**ADDENDUM NO. 1
TO CONTRACT DOCUMENTS FOR THE
PERMANENTE CREEK FLOOD PROTECTION PROJECT-
RANCHO SAN ANTONIO DETENTION BASIN
Project No. 26244001; Contract No. C0617**

ATTACHMENT 1: Revised Plan Sheets G-2, G-5, D-3, D-4, C-13, C-30, C-31, C-33, C-51, C-74, C-75, and EC-5

PROJECT NUMBER: **26244001**
 SHEET CODE: **D-3**
 SHEET NUMBER: OF

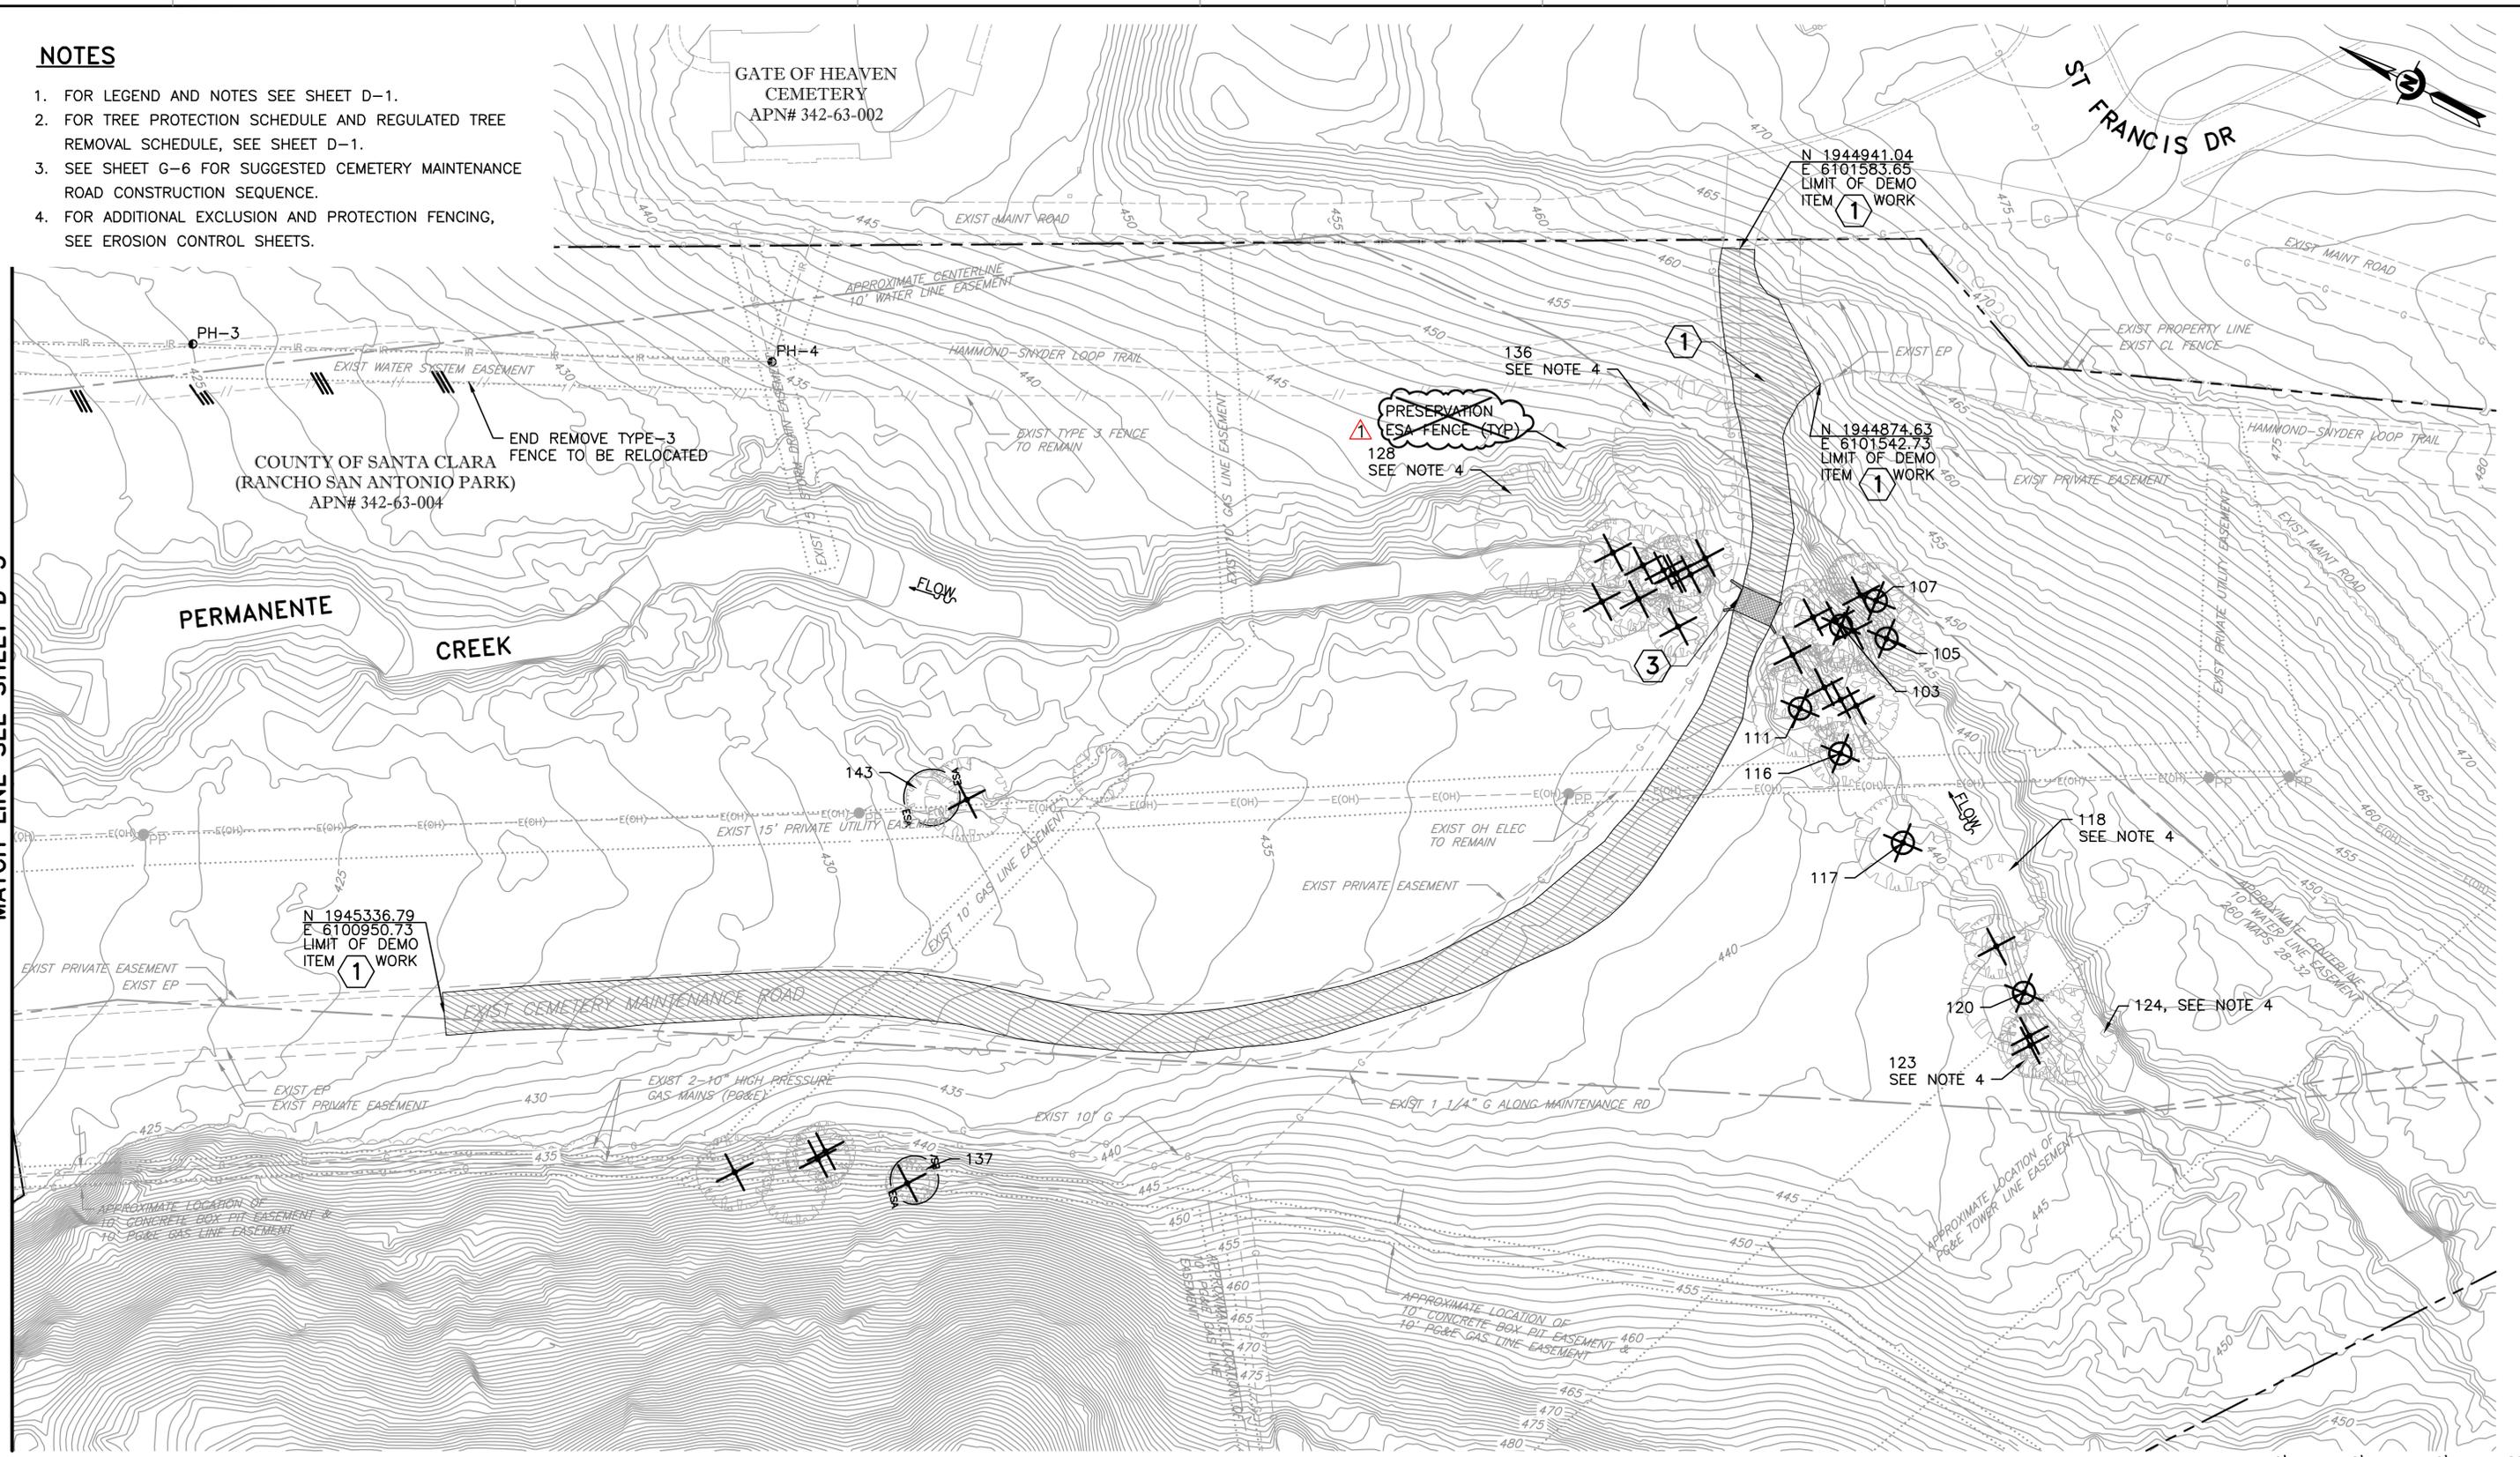
RESPONSE 8.	See Addendum 4 for revision to quantity.
QUESTION 9.	What is the depth and diameter of the existing irrigation well to be abandoned per bid item 98 and where is it located on the plans?

RESPONSE 9.	The existing Irrigation well is shown on Sheet G-11 and on Sheet D-3. Estimated depth of existing well is 41 feet, based on 2009 well pump replacement records. However, please note that previous records indicate existing well depth is approximately 80 feet. Estimated diameter of existing well is 8 inches.

DETAIL 5 NORTH BASIN BOTTOM SECTION
NO SCALE

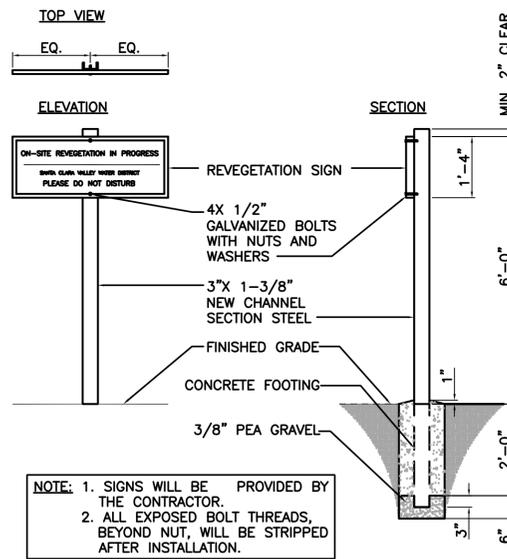
RESPONSE 19.	See Addendum No. 3, Sheet C-13 and Sheet C-33.
QUESTION 20.	Is moderate permeability soil supposed to be used for the basin bottom mounding shown on plan sheet L-02?

QUESTION 34.	Can you clarify were the low/med. Permeability soil goes? L-5 Refers to L-2, but is not called out on L-2. Prob. the diff. from the Nominal bottom of basin elevation and the

grades on sheet L-2? Please clarify sheet L-2 does not show were each type goes.
RESPONSE 34.	See Detail 5, Sheet L-16 for low and moderate permeability soil at basin bottom.

RESPONSE 20.	The moderate permeability soil is to be used for the top 6 inches of the basin bottom and top 6 inches of the mounds. See Detail 5, Sheet L-16 for limits of low and moderate permeability soil placement. Additional details will be provided in the next Addendum No. 5.
